Solicitation No. 26-FM-0010

Amendment No. 3

ADDENDUM NO. 2

Project: Oklahoma Department of Transportation – Multipurpose Facility
Location: Stillwater, Oklahoma
Issued Date: 23 January 2026

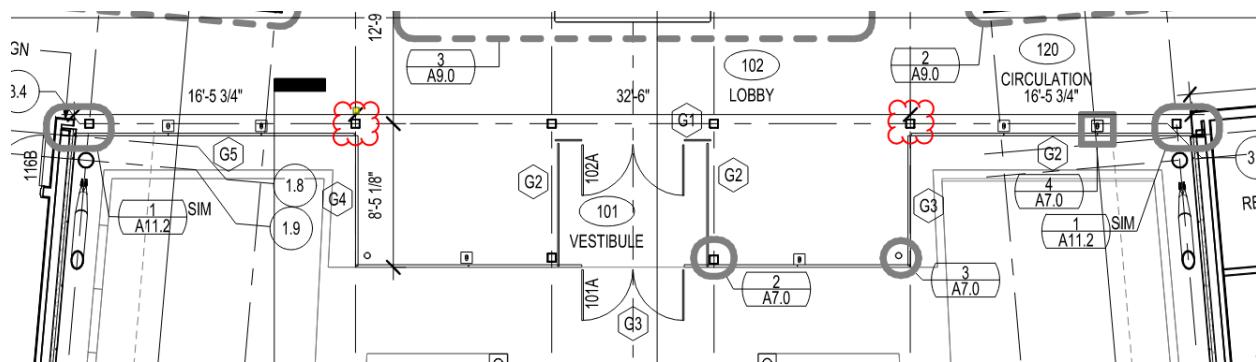
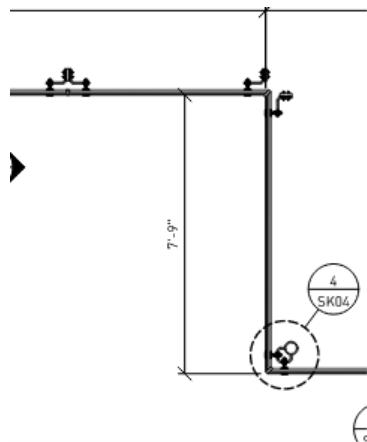
Q 51: At the clouded locations on A2.0, below, the drawings show no steel fins and instead just have structural columns (by others). In previous pricing estimates, Novum had been including (2) steel fins at each corner. See second snip below. It may be cleaner to have at least one steel fin at this location rather than trying to have extended glazing arms coming off the steel by others to pick up both lites of glass. Is it acceptable to do so, or should we develop a solution with custom glazing arms that attach to the HSS column?

A 51: See upcoming addendum.

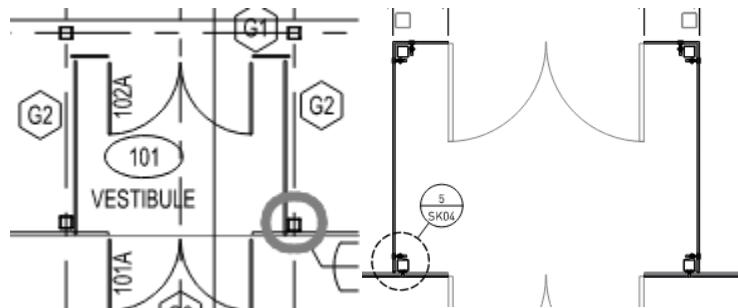
Q 52: On sheet A2.0 at the south wall vestibule, what is shown for structure does not match what Novum has offered in previous pricing estimates. See snip on left below for what is shown in the architectural drawings, and snip on the right below for Novum's vestibule layout. We *will* need to provide more structure than what is shown, but should we keep the HSS tube at the front of the vestibule outside of the vestibule as shown in the Architectural drawings? This will probably make for trickier detailing but may be possible.

A 52: See upcoming addendum.
